REQUEST

Current Zoning: R-3 (single family residential)
Proposed Zoning: UR-2(CD) (urban residential, conditional)

Approximately 4.81 acres at the intersection of Marvin Road and Old Ardrey Kell Road, on the eastern side of Johnston Road.

PLANNING STAFF REVIEW

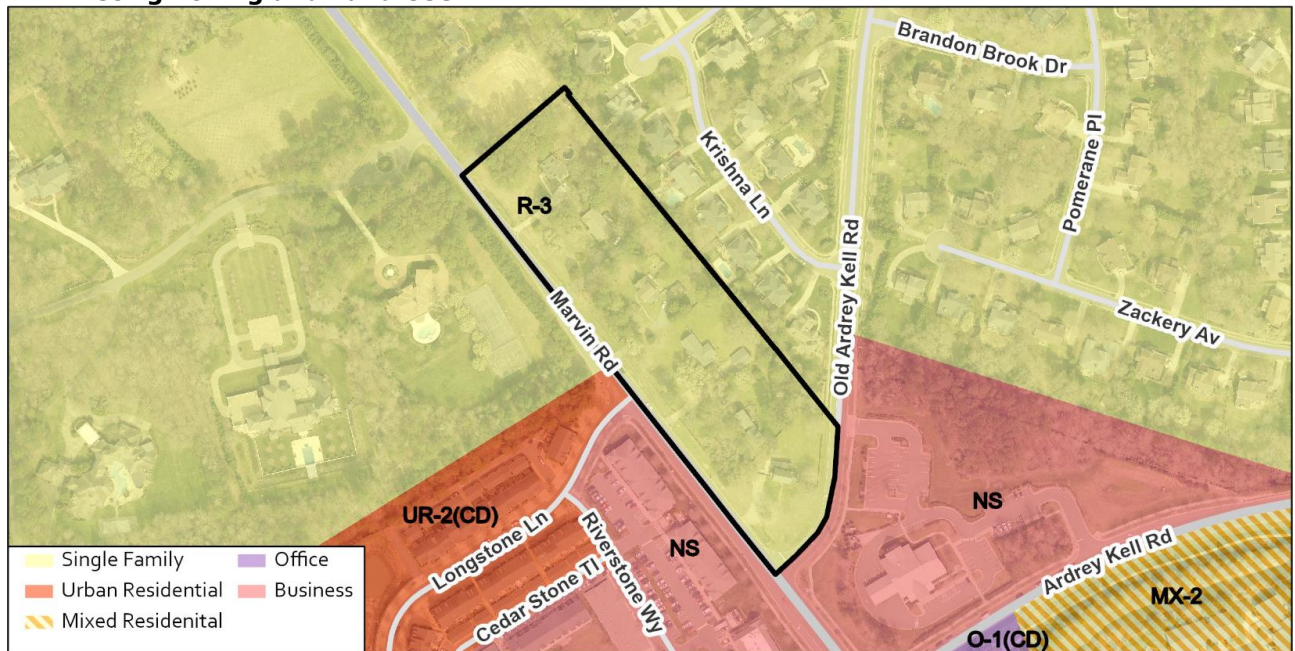
1. Amend the site plan to provide masonry screen walls and landscaping at the end of each private alley facing the public streets. Addressed
2. Provide setbacks from Marvin and Old Ardrey Kell Roads as measured from future back of curb. The setback along both frontages should reflect the location of the buildings depicted on the plan, not the Ord. minimum. Addressed
3. Annotate the concept renderings to point out key features of the proposed building design. Addressed

4. Show space for solid waste and recycle receptacles even if private, rollout collection is planned. Addressed
5. Amend note H.1 to specify a minimum size for open space areas. Addressed

6. Add the following note to the site plan, "The location, size, and type of storm water management systems depicted on the Rezoning Plan are subject to review and approval as part of the full development plan submittal and are not implicitly approved with this rezoning. Adjustments may be necessary in order to accommodate actual storm water treatment requirements and natural site discharge points." Addressed

7. Add the following note to the site plan, "For adjoining parcels receiving storm water discharge the petitioner shall analyze the adequacy of the existing storm water conveyance on the adjoining parcels to the nearest public R/W. If the existing storm water conveyance on the adjoining parcels is found to be inadequate, the Petitioner shall make a good faith effort with the property owner(s) to improve the storm water conveyance or mitigate the storm water discharge onto the adjoining parcels." Addressed

8. Based on feedback from the community, please revise the dimension of the concrete island proposed on Old Ardrey Kell Rd. to allow room for more left turn storage at the Old Ardrey Kell and Marvin Rd. intersection. Addressed, the petitioner and NCDOT/CDOT have discussed the issue and have come to an agreement.

9. Clarify in the notes that tree save area is to be "preserved" replanted tree save is not an option. Addressed
10. Amend the label for the buffer/tree save area to state "Preserved Tree Save" and that within the buffer/tree save area where preserved trees do not exist to meet the buffer standard additional plantings will be provided such that the buffer meets a Class C standard. Addressed
